OIML TC 18/SC 1/p 2

Document: **TC18\_SC1\_P2\_N015**

Date: 2018-12-12

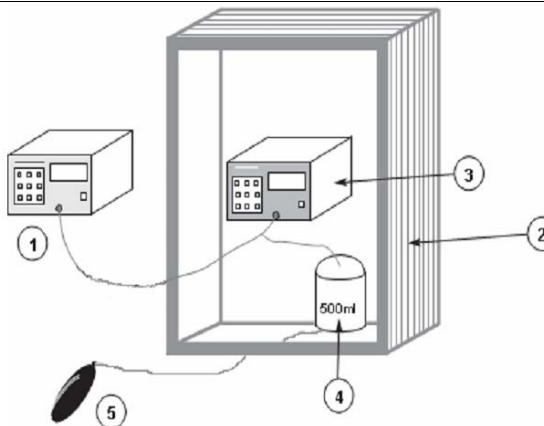
113.	BR	A.3 Figure 2	The air from the pump should connect first to the metal vessel and then to both manometers.	 <p>Use the new Figure 3 at R 16-1 revision (below)</p>	accepted

114.	DE	A.3 .2Fig. 2	The tube from the pressure generator (5) should go to the lower part of the metal vessel (4).	I can send revised drawing later.	accepted

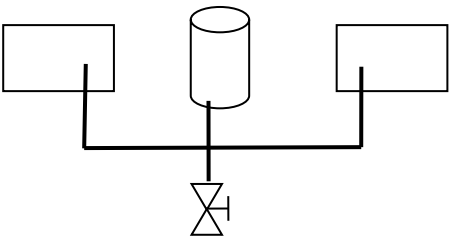
140.	BR	Figure 5	This figure is mentioned in A.6.2	 <p>1 – Patient simulator; 2 – Sphygmomanometer 3 – Vessel; 4 – Air leakage device</p>	Not accepted Because not accepted in 6.2
